SERVICE BULLETIN

BULLETIN NO: AM-375-RPJ

EQUIPMENT: MW-1A PA MODULES

SUBJECT: History of updates to MW-1A PA Module.

FIGURE 8-3. RF/PA MODULE
 A1-A13, SCHEMATIC
 828 8512 001
 888-1732-C
 8-7/8

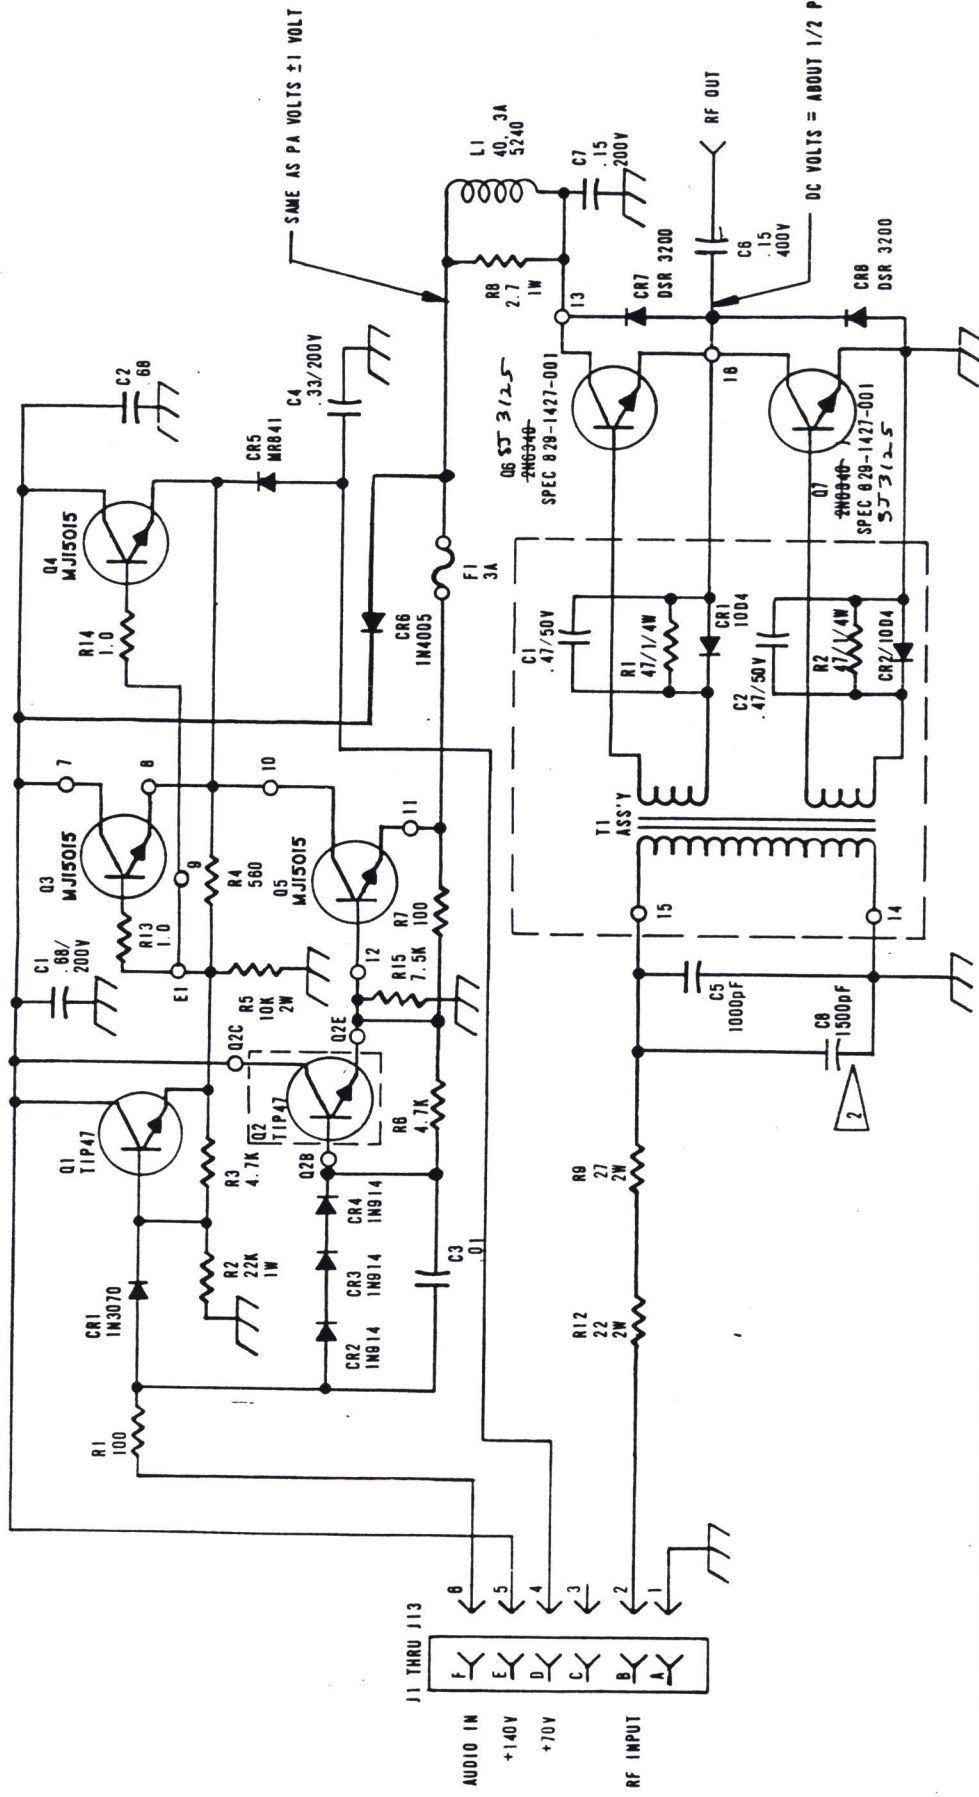
This bulletin contains a history of all updates done to the MW-1A PA modules to date. All items except #1 and #6 should be done to all PA modules to bring transmitter performance up to specification. Items #1 and #6 are not electronically necessary, but do make transistor replacement easier.

1. Transistors sockets XQ-6 and XQ-7, 404-0661-000.
2. Resistor R11 and Pot R10 removed.
3. Resistor R12 = 22 ohm, 540-0571-000.
4. Resistor R9 = 27 ohm, 540-0573-000.
5. CR6 = 1N4005, 384-0020-000. See AM-141-CKH.
6. RF Input Board is installed, 992-5217-001, T1.
7. Q6 and Q7 must be ^{2N5038}~~SJ3125~~ transistors, 380-⁰⁷⁹⁰~~0513~~-000
8. Verify that Q2 is wired per revision N schematic.
9. Verify that DSR 3200 diodes are installed across Q6 and Q7, 384-0678-000. See AM-120-LAP.
10. Q3, Q4 and Q5 = MJ15015, 380-0670-000.
